Errata to ADS528x, Data Sheet Literature Number SBAS397

Revision Identification

Figure 1. Package Symbolization Definition

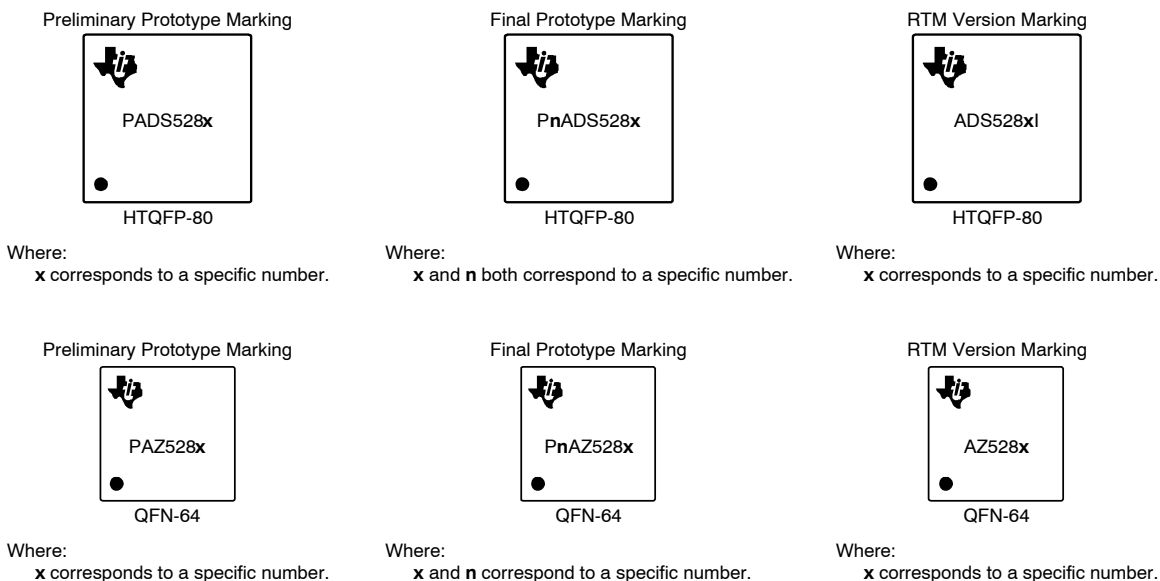
Figure 1 explains the ADS528x package marking for both the HTQFP-80 and QFN-64 packages for the device and the differences between the package marking on the preliminary prototype and how the package marking will appear in the final prototype version as well as the version that is released to market (RTM).

Figure 3 Description of LVDS Timing Diagram Status for Final Version

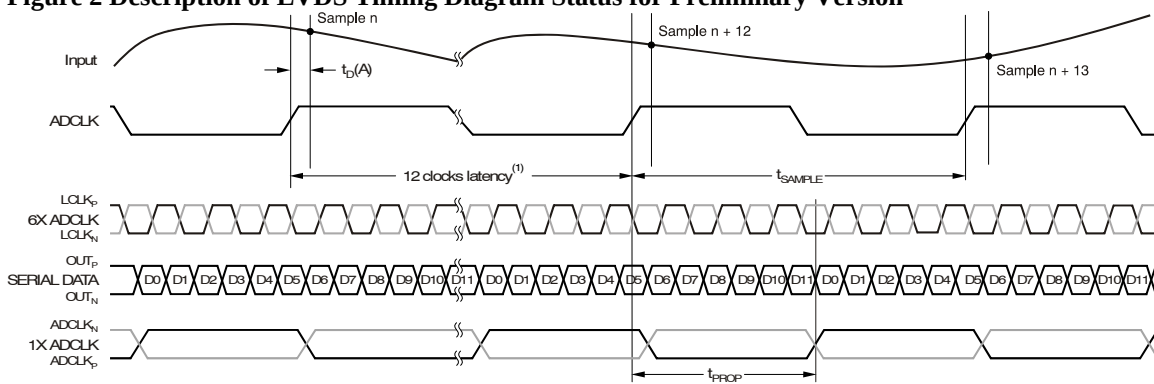
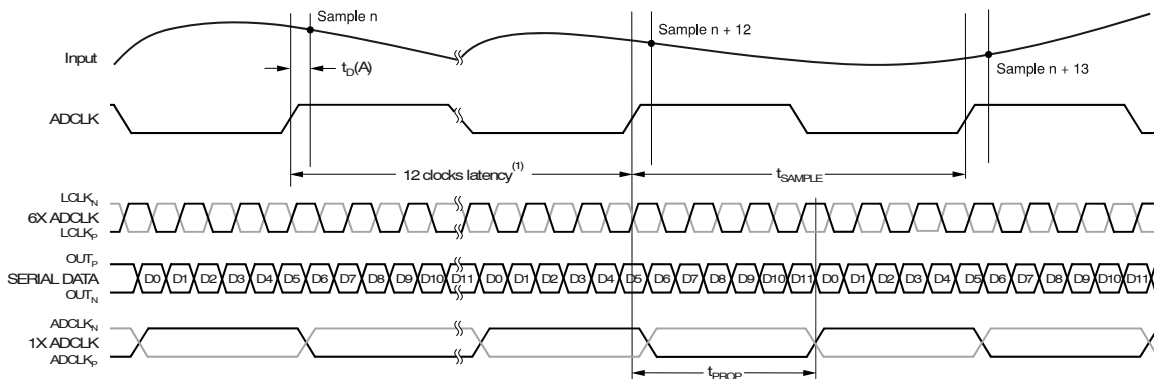
- 1) Inverse polarity of $LCLK_N$ and $LCLK_P$.

The timing diagram for the LVDS signals on the preliminary prototype version is shown in Figure 2. However, Page 6 of the ADS528x data sheet (SBAS397, published December 2006) shows an LVDS timing diagram that matches Figure 3, which is the way it will appear in the final prototype version of the silicon.

Note the inversion in polarity of $LCLK_P$ and $LCLK_N$ in Figure 3, as compared to Figure 2. The first edge of $LCLK_P$ after the rising edge of $ADCLK_P$ will be a falling edge in the final prototype version, as is the case in the ADS527x family. The polarity inversion can also be described as a phase change of 180 degrees.

- 1) If the customer's prototype has built-in deskew capability, it is expected that there will be no impact to the deserializer in this revision. If deskew capability is not available, and the customer is using samples of the preliminary version for prototype development, it is recommended that the customer develop the prototype according to the timing diagram shown in Figure 2 (preliminary prototype version), and build in the capability to handle the polarity inversion of LCLK_P and LCLK_N on the final version.

The TI ADSDer-50EVM high-speed deserializer (SBAU091) has built-in deskew capability. The change in polarity of LCLK_P and LCLK_N will therefore be corrected as a timing skew with respect to the data lines. Therefore, the TI ADS528x evaluation module will be able to work correctly with both the preliminary version as well as the final version **without any change in deserialization code**.
